Addendum

Additions and Alterations to
Elm Street Elementary School
Phase 2

BID Addendum No. 1
to
Drawings and Project Manual

August 20, 2026

Drawn By: KCB / mlj	Date: 02/23/2026	Drawing Number:
Project No.:		BG351

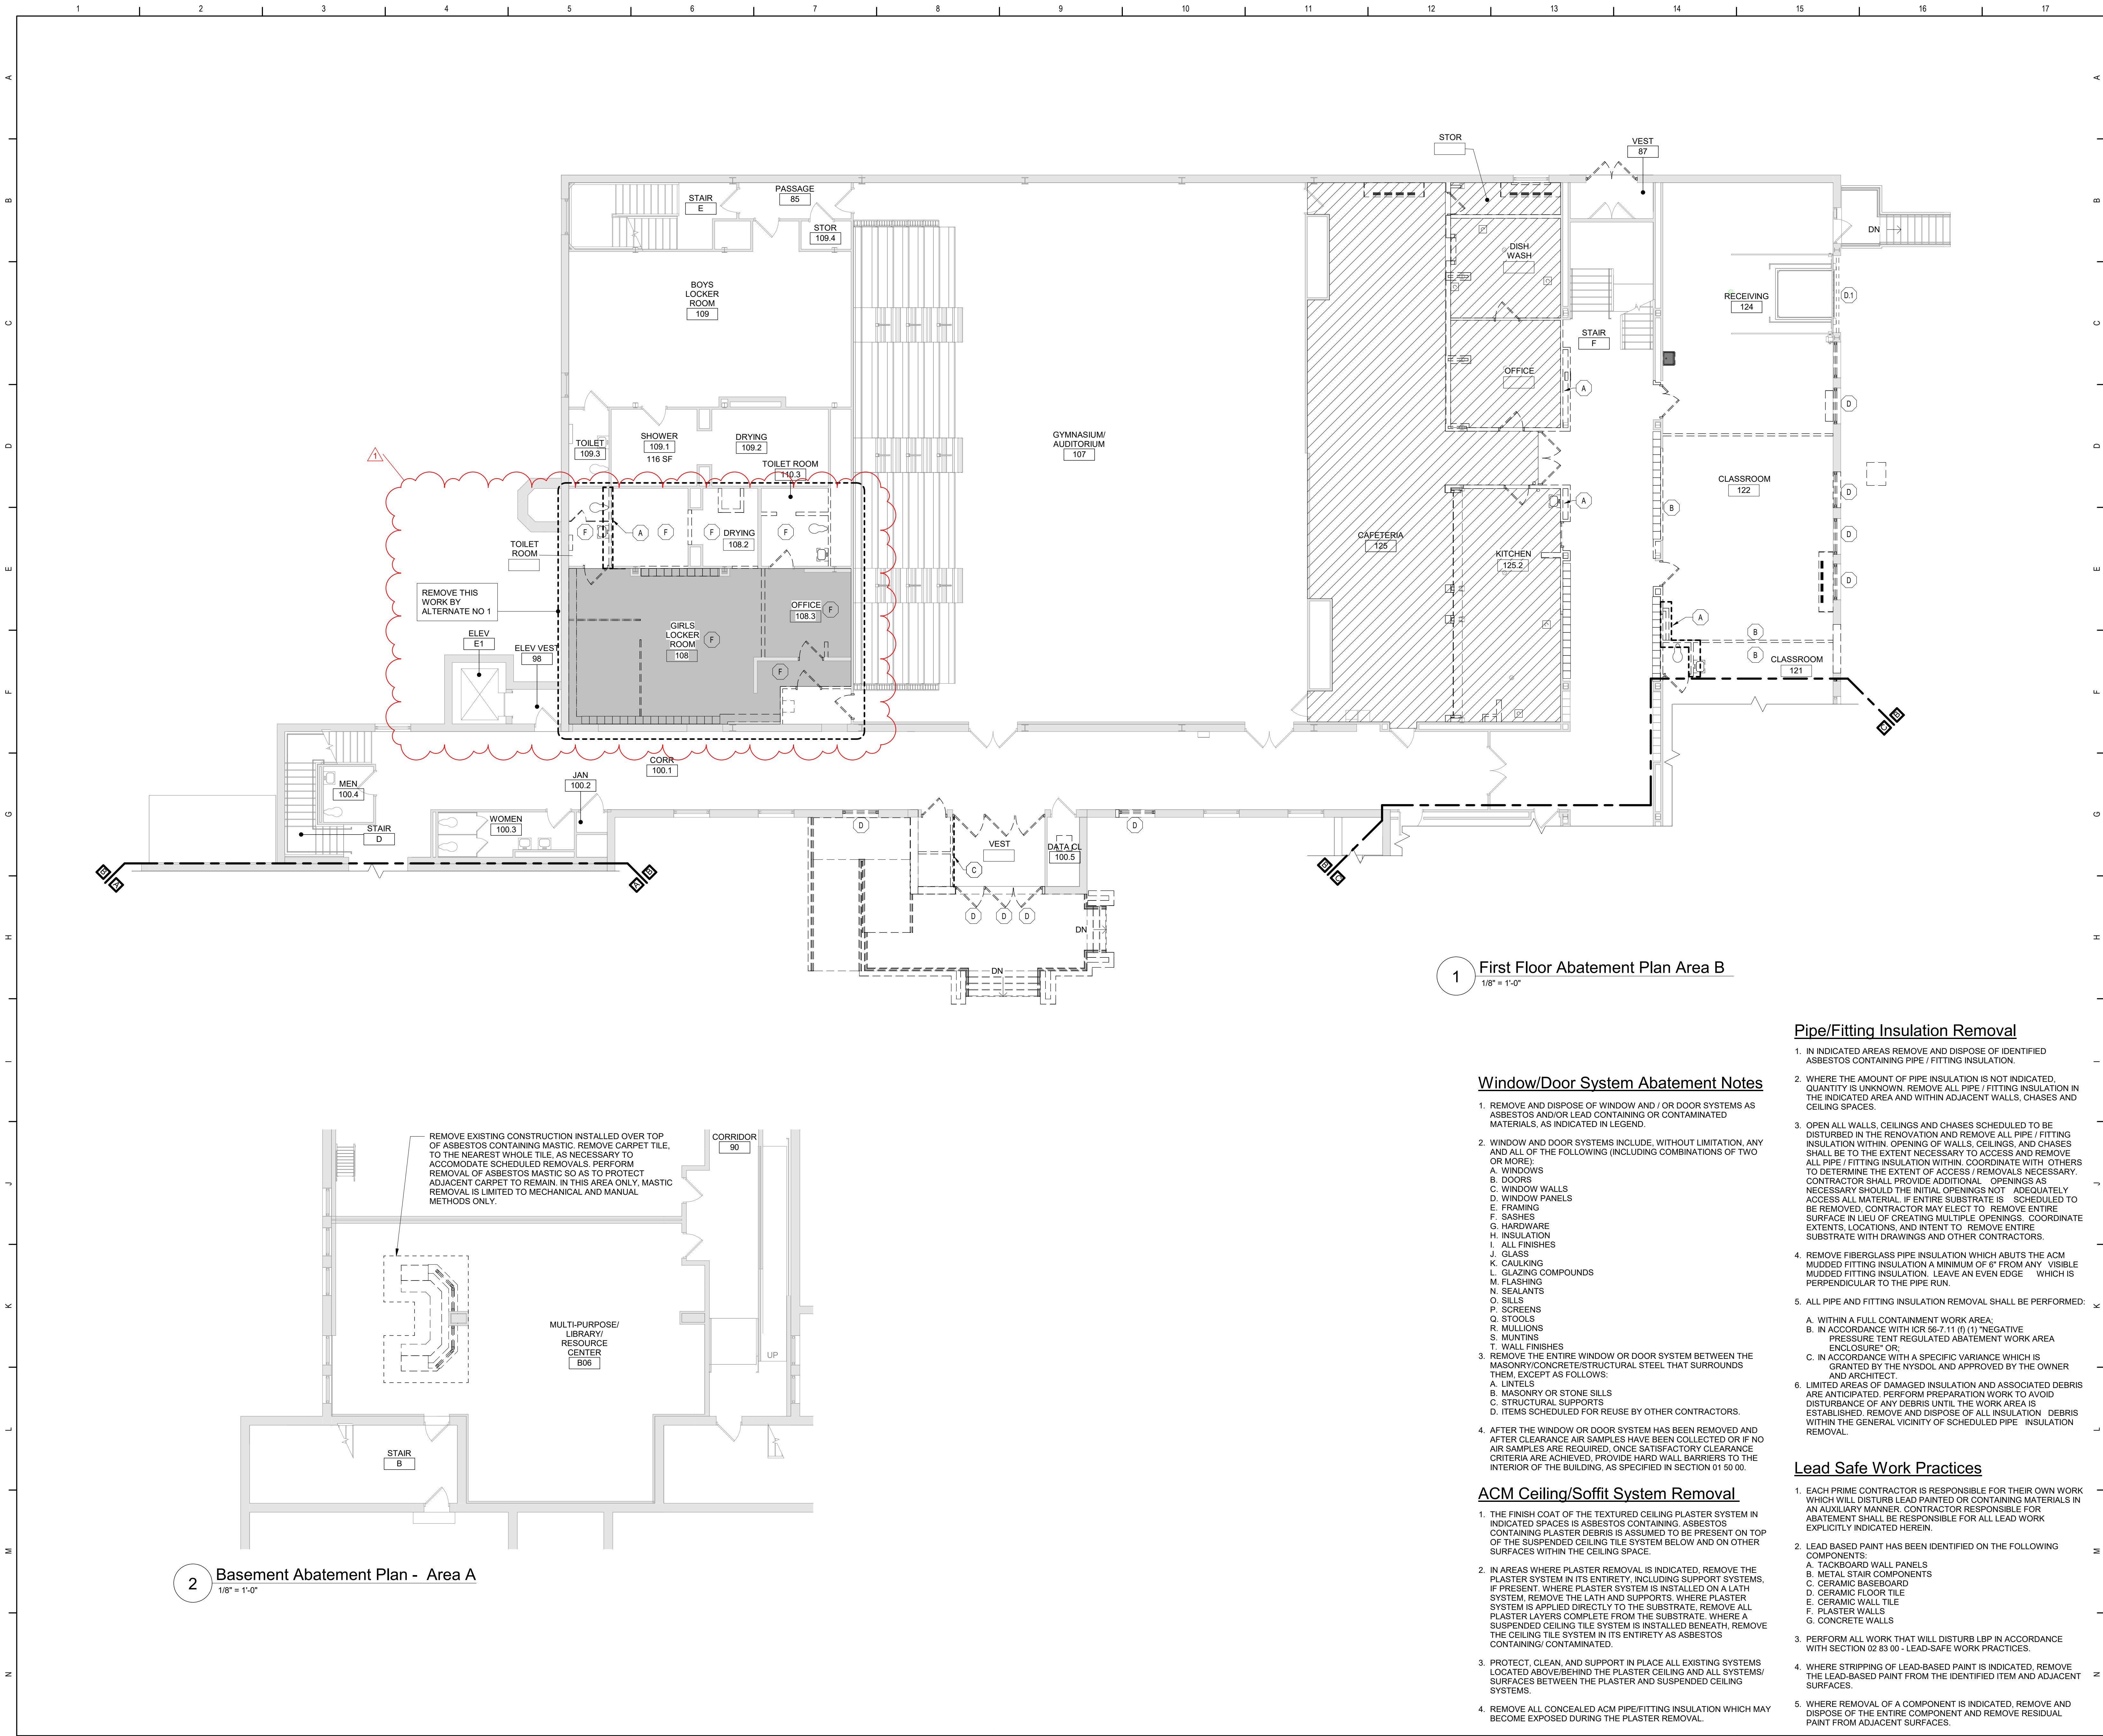
- a. General Contract: Provide the change in the base bid cost if all work associated with the demolition and renovation of the following Health Suite related spaces, as indicated on Drawing BG351, are eliminated from the Contract scope of work: Jan 108, Health Suite 110, Classroom 111, Special Education 12:1:1 113, Office 126.1, Office 126.2, Faculty Room 202, Vestibule 150.1 and Speech/OT 114B.

Question: (Please be specific) There is a discrepancy between drawing BG351 food service area and spec section 01 23 00 Alternates 1D. the drawing shows the food service area hash marked to be included in alternate #01 but the spec section does not call out the following room numbers 123, 125, 125.1, 125.2

Please refer to BID Addendum No. 1. for re-issued drawing BG351 and alternate language update in spec section 01 23 00.

Drawn By: TJT	Date: 02/23/2026	Drawing Number:
Project No.: 339070-25002	BH101

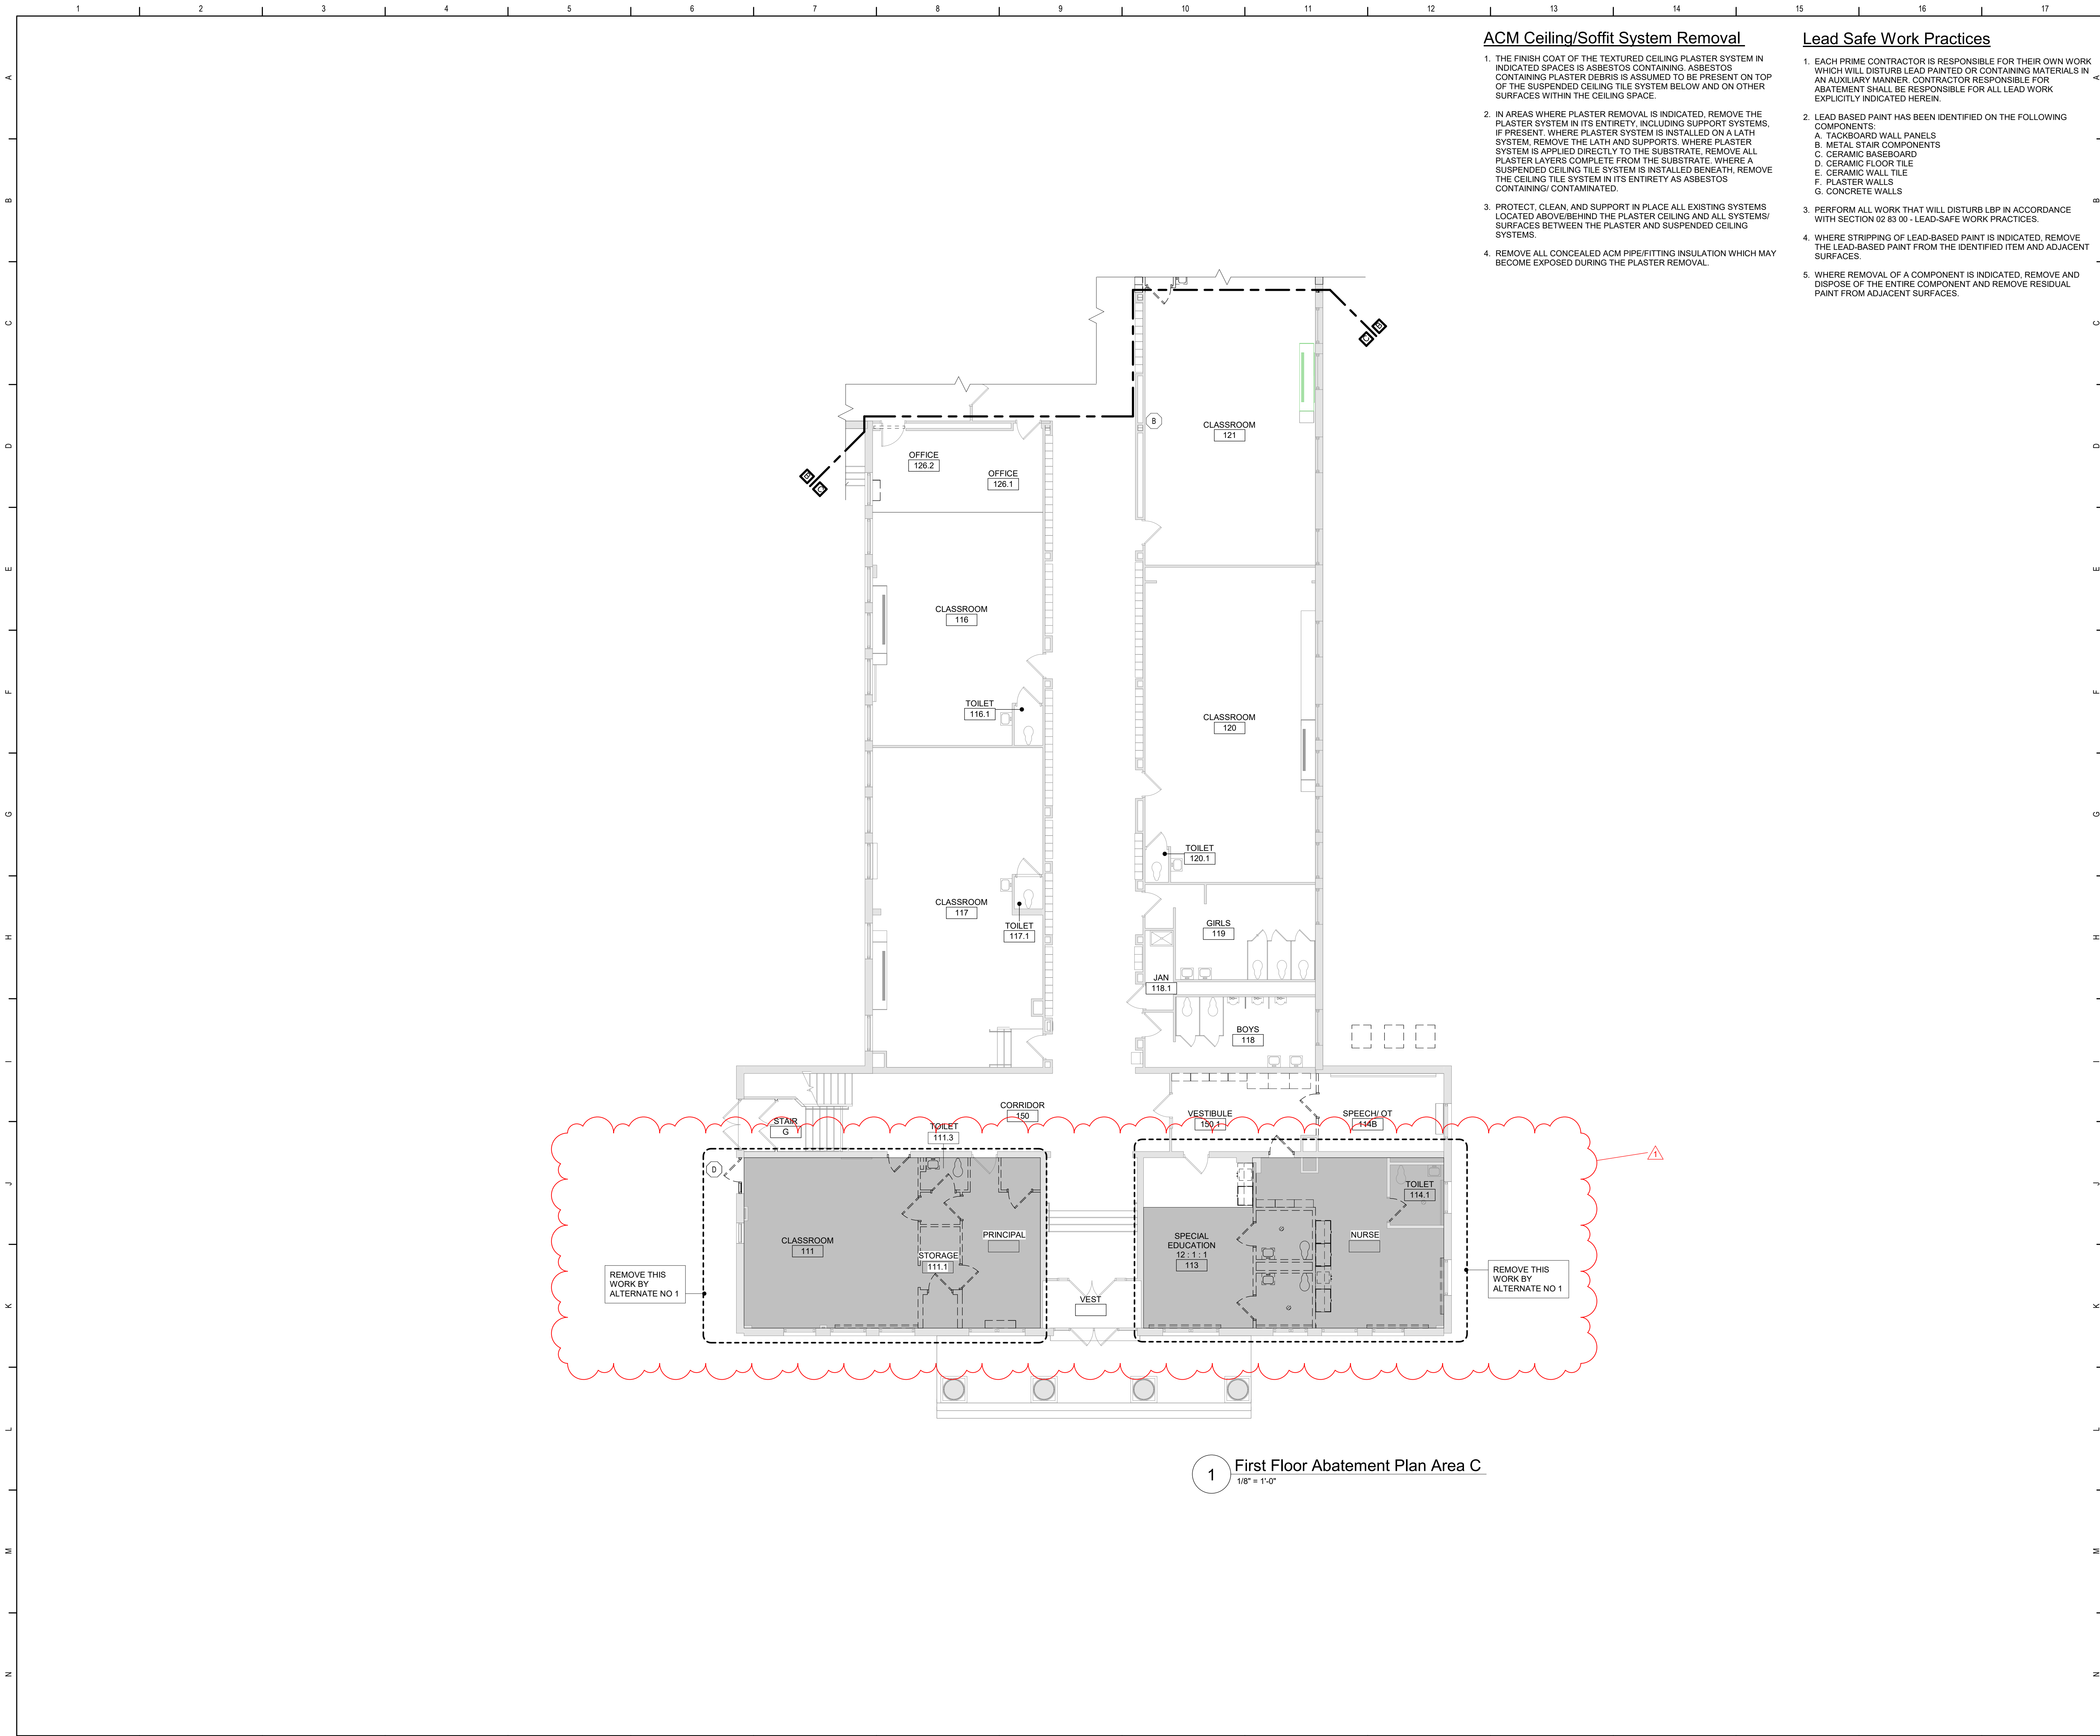
Please confirm all work shown on BH101 is in deduct alternate 1

Please Refer to Bid Addendum No. 1
